REMARKS

This amendment is in response to the Office Action of October 20, 2004.

Fig. 1A

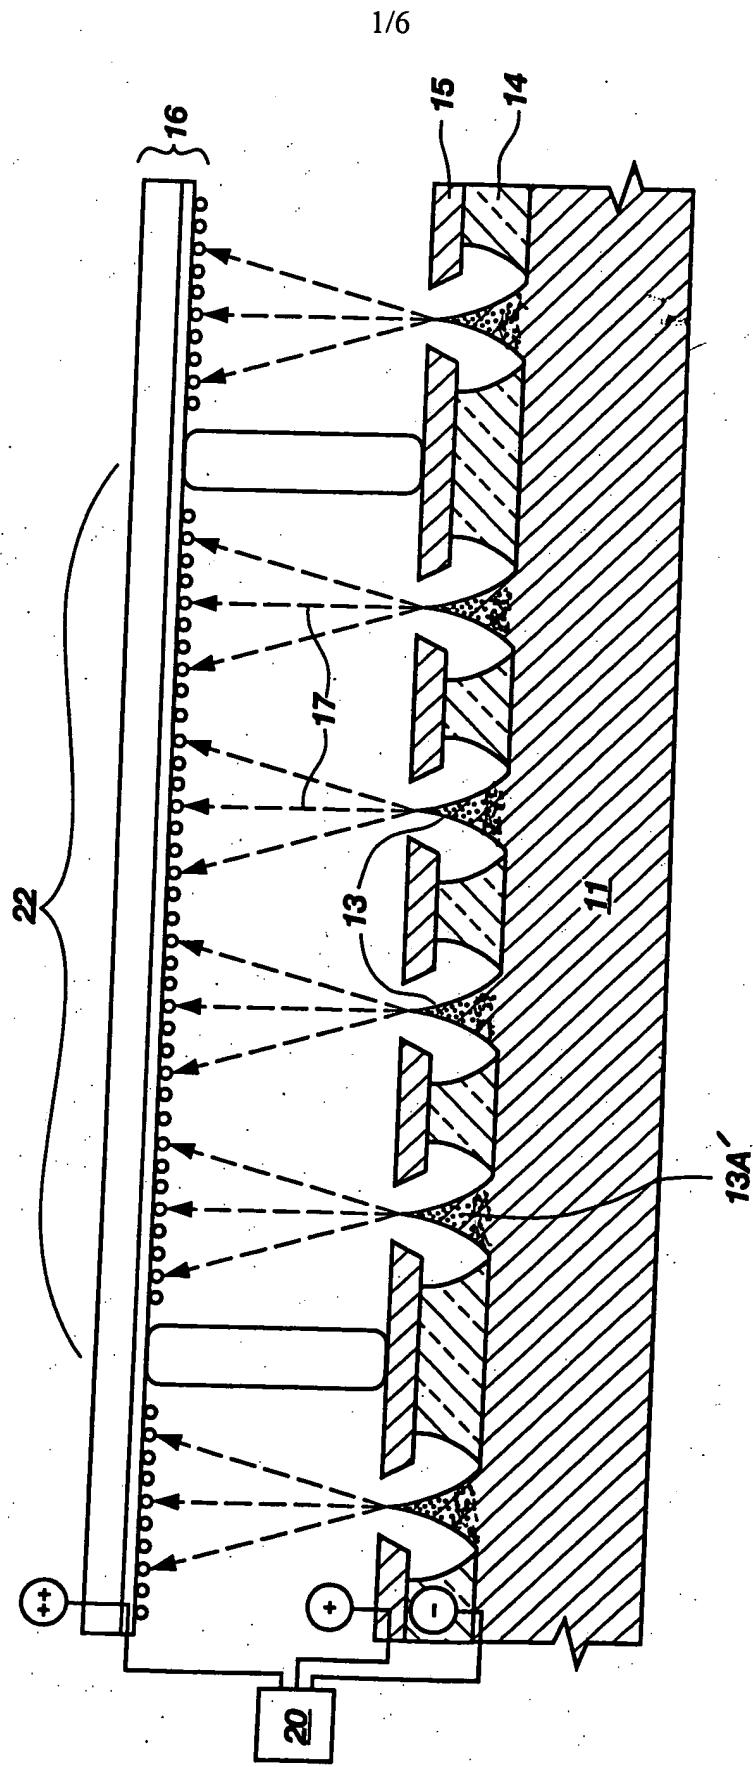
Applicant previously submitted Figures 1, 2, 3, 4, and 5. Applicant now desires to submit for approval new formal drawings of Figure 1A, Figure 2A, Figure 3A, Figure 4A, and Figure 5A with this amendment. Each of such drawing figures illustrates an alternative of the present invention where the dopant 13A concentration increases with depth into the substrate 11. Marked-up drawing figures for each of such drawing figures are further submitted with this amendment to show the drawing changes for the increasing dopant 13A concentration.
